Springbank Reservoir Project
Alberta Transportation

Subject: Outcome of the review of Alberta Transportation's responses to federal information requests for the Springbank Off-Stream Reservoir Project

Springbank Off-stream Reservoir Project

Response to
Agency Conformity
Review of
Round 1 Part 3,
dated August 21, 2019

Figure 1-1 Flood Frequency Distributions with Climate Change Projections to 2050

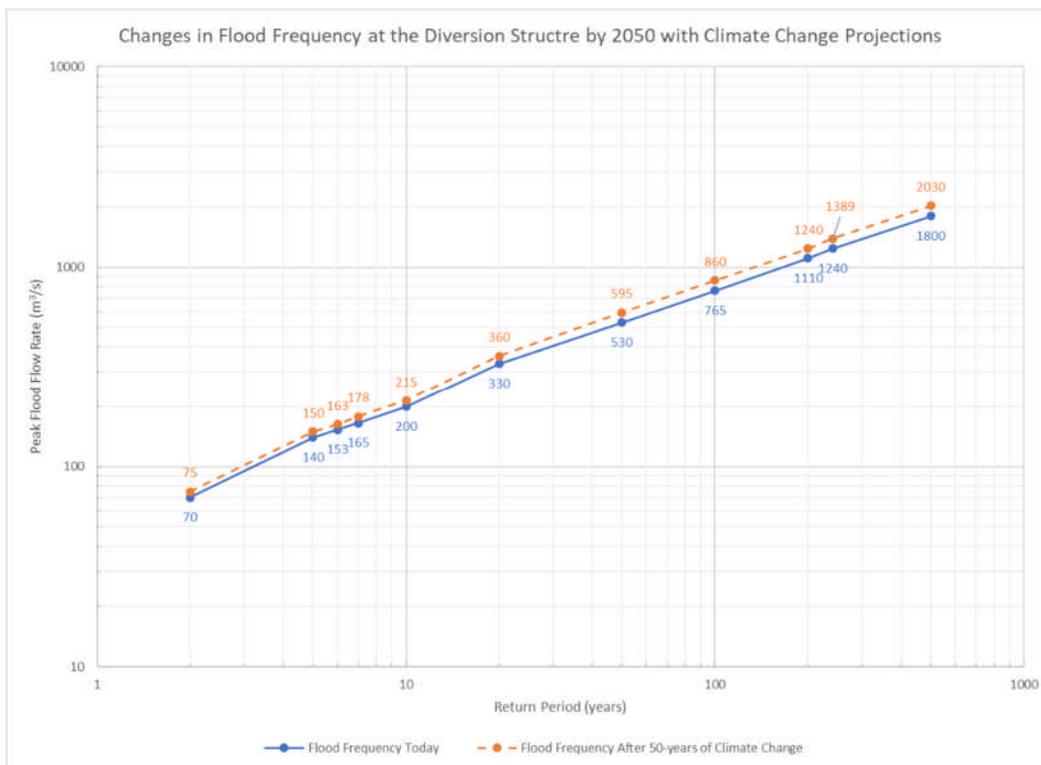
In IR3-01 b) i), the Agency required a flood frequency and size analysis considering future changes in regional climate. Alberta Transportation's response reiterates the flood frequency analysis that is provided in the EIS, without a rationale as to how this considers future climate change related effects.

- a) Provide a new flood frequency analysis given the potential increase in frequency and severity of floods.**
- b) Provide an assessment of effects of the environment on the Project should a flood larger than the design flood occur and should flooding occur more frequently due to climate change, and associated potential effects to VCs.**

- a) There is no federal or provincial standard method to estimate the climate change impact on flood magnitude and frequency. A flood frequency analysis that considers the effects of current projections on climate change was executed using the IDF_CC tool that has been developed by the University of Western Ontario and the Institute for Catastrophic Loss Reduction (<https://idf-cc-uwo.ca/>). As indicated in their user manual, "one of the primary objectives of the tool is to standardize the IDF updating process and make the results of current research on climate change impacts accessible to practitioners". This tool was developed to help engineers and planners quantify the impacts of climate change projections on the intensity-duration-frequency (IDF) curves that are produced by Environment Canada and Climate Change (ECCC). ECCC's IDF curves are distributed under their Engineering Climate Datasets (https://climate.weather.gc.ca/prods_servs/engineering_e.html). These datasets are used across Canada in the design of municipal water management infrastructure.

8. Step 1 to step 6 were then executed using the climate affected IDF rainfall data to produce a flood frequency distribution that considers climate change projections. The results are provided in Table 1-1 and Figure 1-1.

The flood frequency analysis results suggest that the operational flow threshold of 160 m³/s, which has an associated return period of approximately 1:7 years (i.e., 165 m³/s in the second column of Table 1-1) may have an associated return period of approximately 1:6 years under climate change projections (i.e., 163 m³/s in the third column of Table 1-1). The predictions indicate the severity of floods will be higher when climate change is considered (i.e., the flows with climate change in the third column for each specific flood return period in Table 1-1 is larger than the flow in the second column). As flood frequencies increase, there is a potential for the Project to be operated more frequently due to climate change effects.

Figure 15-1

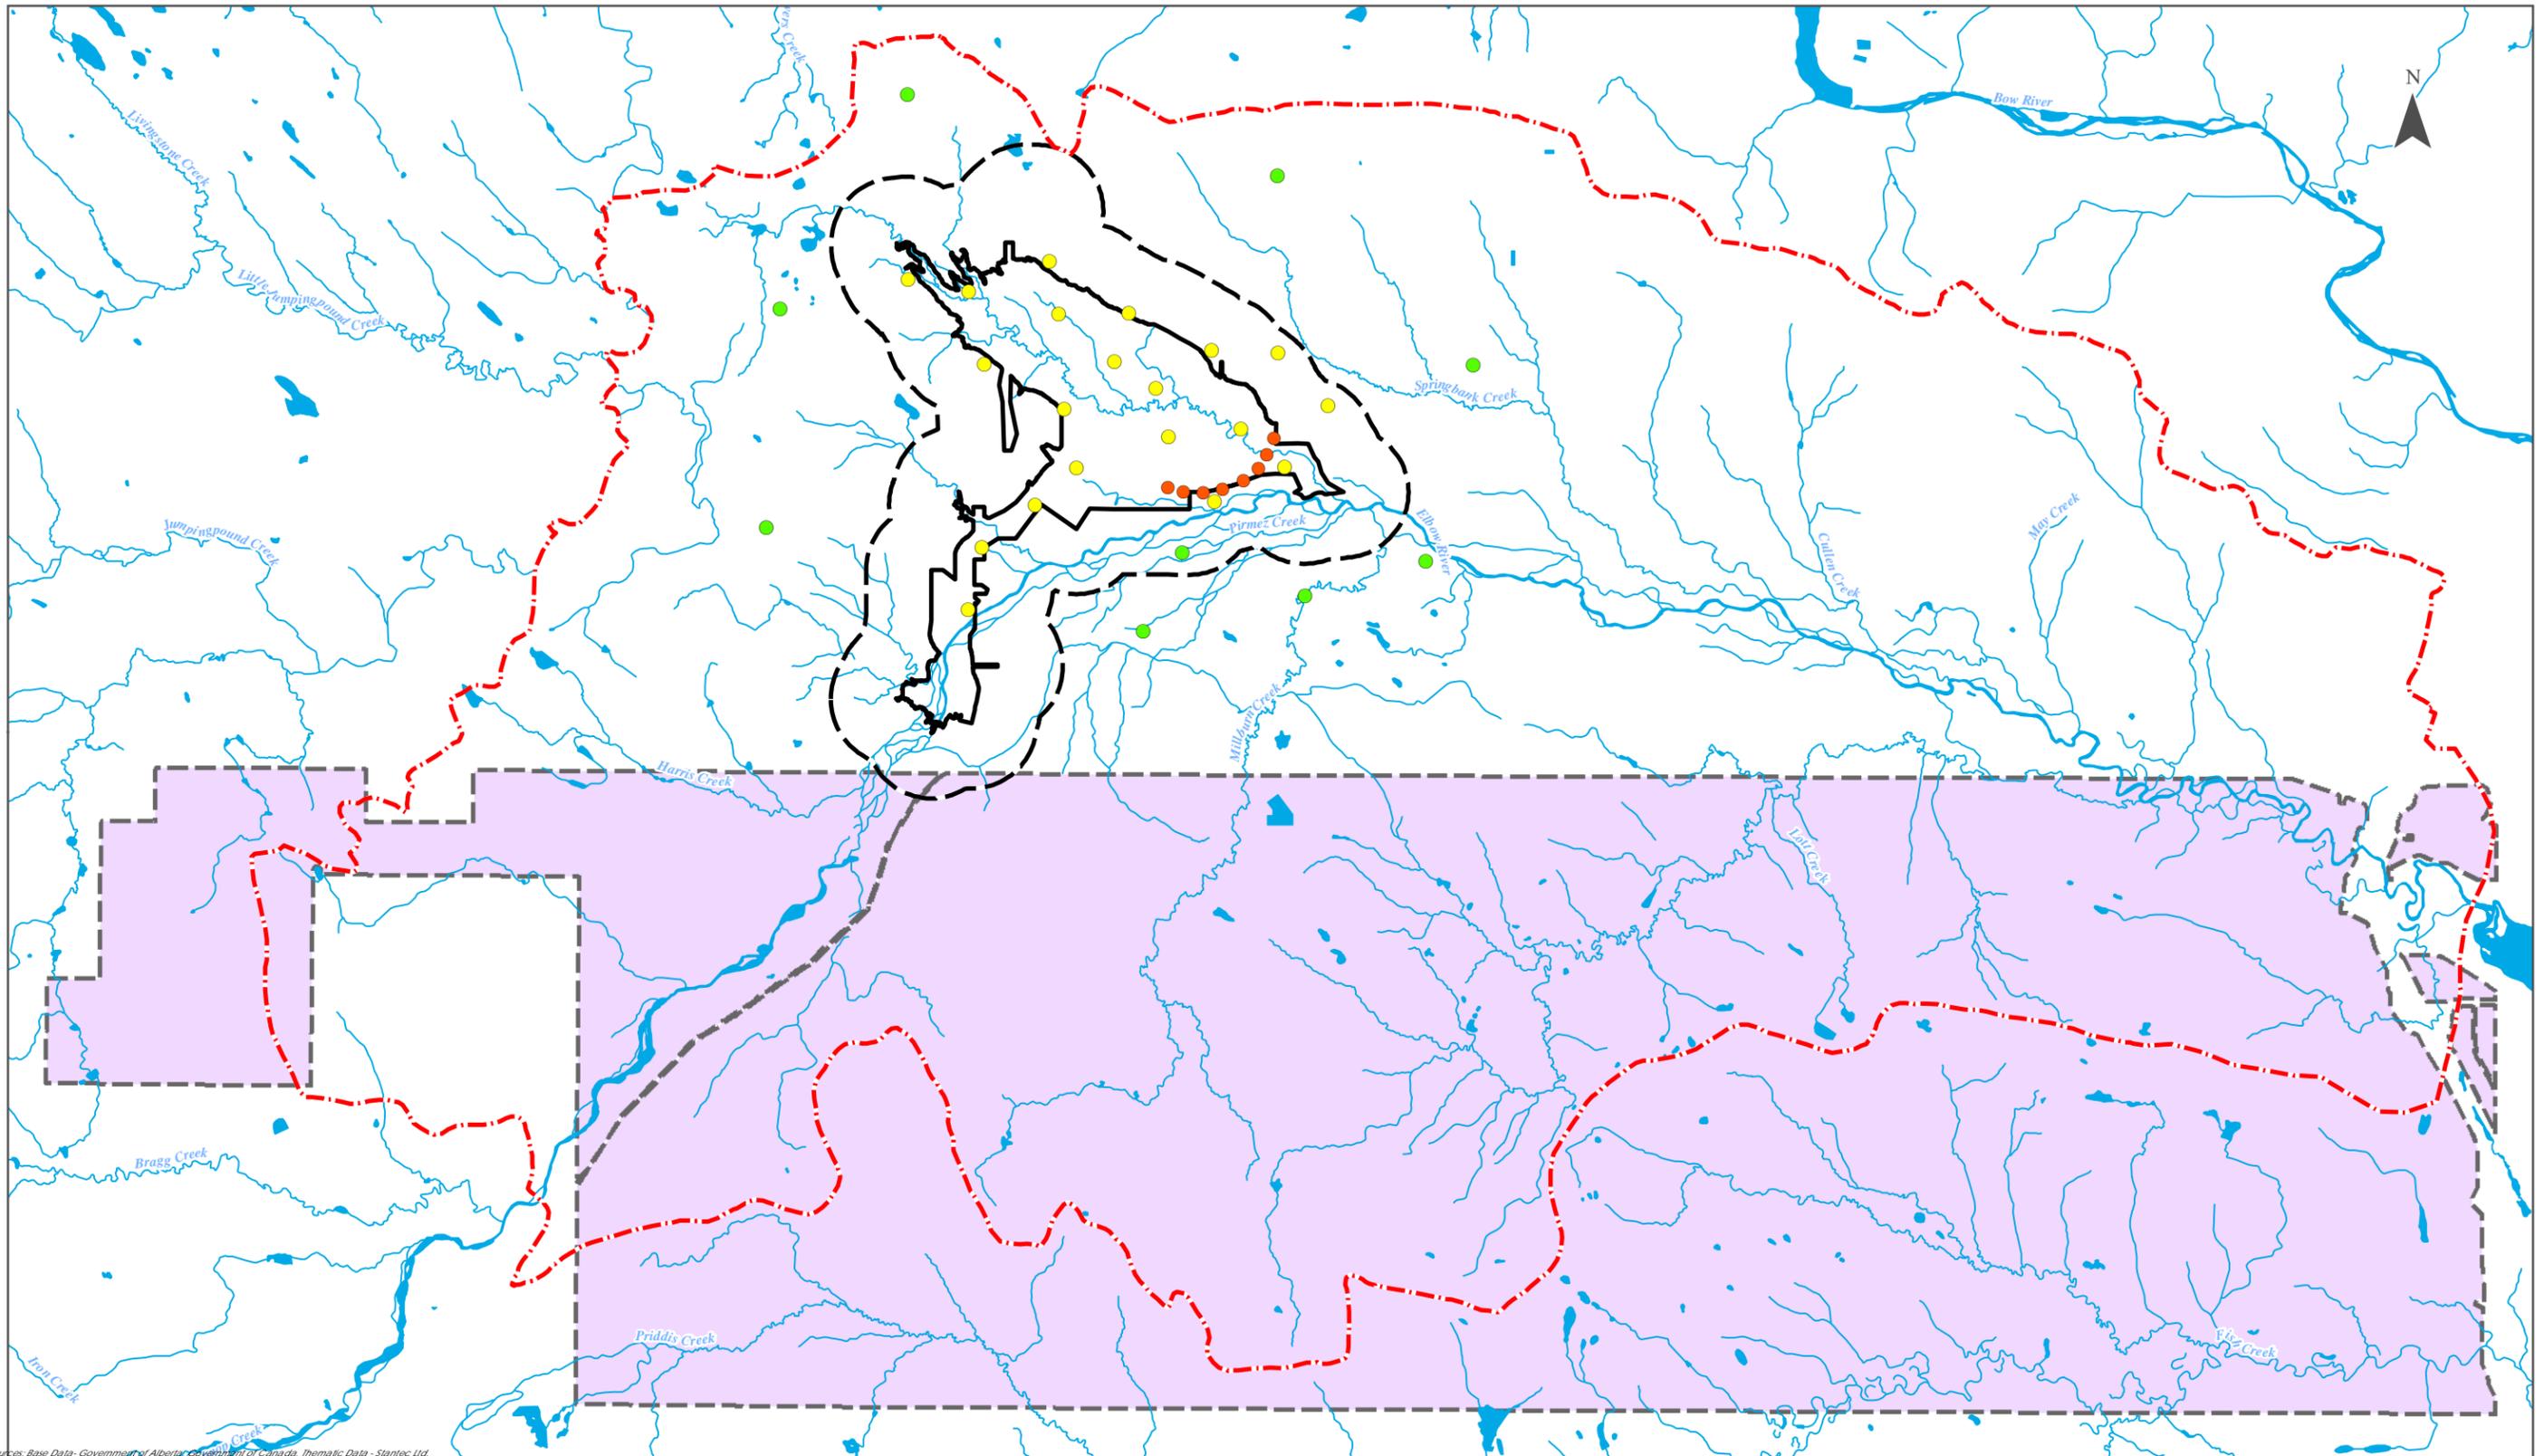
In Alberta Transportation's response to IR3-15, Alberta Transportation provides a draft groundwater monitoring plan. However, no specific discussion regarding the potential for the use of dedicated monitoring wells for groundwater head monitoring is included. As noted in the information request, the EIS only discusses the use of domestic water wells in follow-up and monitoring. The purpose of the follow-up program is to validate the results of hydrogeological modelling and domestic wells on their own are of limited value to evaluate water level predictions. The use of dedicated monitoring wells to allow groundwater head monitoring for both dry operations and flood/post-flood response should be considered.

Additionally, the draft groundwater monitoring plan indicates that all monitoring wells to be included in the plan have been or, in the case of proposed wells, will be developed following completion. This does not provide clarity on whether any current monitoring wells will be maintained for use in follow-up and monitoring.

Tsuut'ina IR 145 is shown in the figures for the draft groundwater and monitoring plan for reference; however, information specific to what will be occurring on Tsuut'ina IR 145 is not included. For readability and clarity purposes, a specific section of the plan on follow-up and monitoring for Tsuut'ina IR 145 is required.

The proposed monitoring network is presented in Figure 15-1 (adapted from the Groundwater Monitoring Plan). A total of 11 Project wells will be decommissioned, nine Tier 2 wells will be decommissioned and replaced, and 12 Tier 2 wells will be retained. The monitoring wells that are planned to be decommissioned and replaced will be replaced as close as possible to the original location but outside the inundation area or construction footprint. In addition to the Tier 2 wells that will be retained or replaced, three new monitoring well locations will be established around the perimeter of the PDA to improve the spatial distribution of the monitoring network.

Figure 17-1 Calibrated Hydraulic Conductivity Through the Local Assessment Area

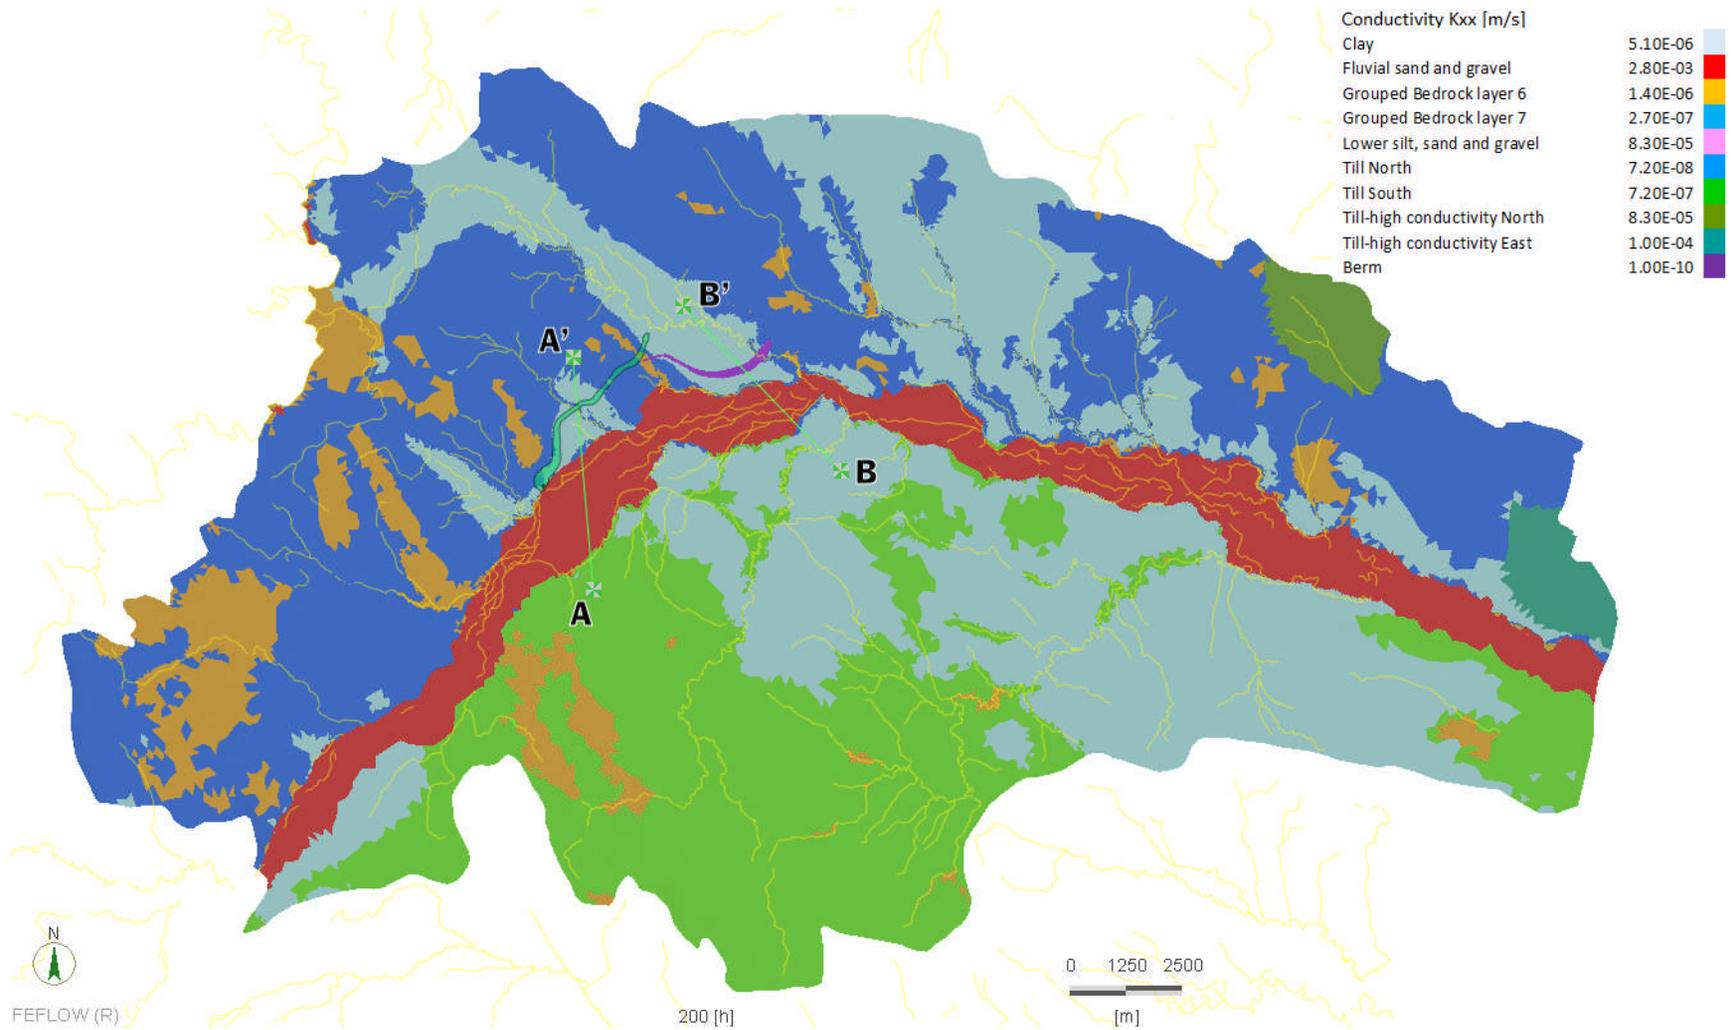
In IR3-17 e) the Agency required Alberta Transportation to provide additional details on hydraulic conductivities. In Section 4.5.3 of the Hydrogeology Technical Data Report, Alberta Transportation provides a table that notes the various hydraulic conductivities for each hydrostratigraphic unit. However, this table does not show the initial and final (calibrated) values, and does not report the anisotropy ratio as requested in IR3-17 e). Additionally, it is unclear if the concerns regarding hydraulic conductivities noted in part e still exist.

- **Provide maps and cross-sections of final calibrated hydraulic conductivities values, and the three zones of calibrated bedrock hydraulic conductivity**

- Figure 17-1 and cross sections (Figure 17-2 and Figure 17-3) present the calibrated hydraulic conductivity through the local assessment area (LAA). Two zones of calibrated bedrock hydraulic conductivity are used in the revised numerical model presented in the TDR Update. The use of two model layers is considered appropriate to represent an upper layer of the bedrock (Layer 6) which is considered to have more open fractures (i.e., higher permeability) compared to the lower bedrock (Layer 7). The calibrated hydraulic conductivities for the two bedrock units support this interpretation.
